UNITED STATES PATENT AND TRADEMARK OFFICE

APPLICATION NO. FILING DATE FIRST NAMED INVENTOR ATTORNEY DOCKET NO. CONFIRMATION NO. 05/17/2001 James M. Gust GRD0122.CIP 4110 09/859,718 EXAMINER 03/02/2004 Todd T. Taylor PATEL, DHIRUBHAI R TAYLOR & AUST, P.C. ART UNIT PAPER NUMBER 142 S. Main St. P.O. Box 560 2831 Avilla, IN 46710

Part III DETAILED ACTION

SKETCH "A"

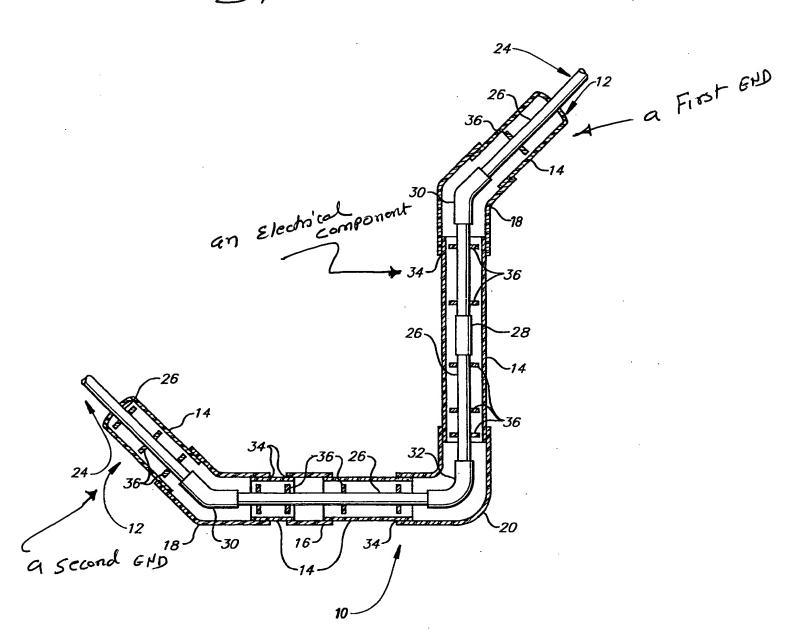
Regarding claim 1, at least one electrical conductor 24 (see fig 1, column 4 lines 65-67), a

flexible electrical tubing 12 having a first end and a second end (see sketch A), said tubing

loosely carrying said at least one electrical conductor (see fig 1); said at least one electrical

conductor traversing said tubing from said first end to said second end (see sketch A)and an

electrical component 34 associated with said at least one electrical conductor (see fig 1), said

electrical component solely hermetically sealing said first end (see sketch A, column 5 lines

24-35).
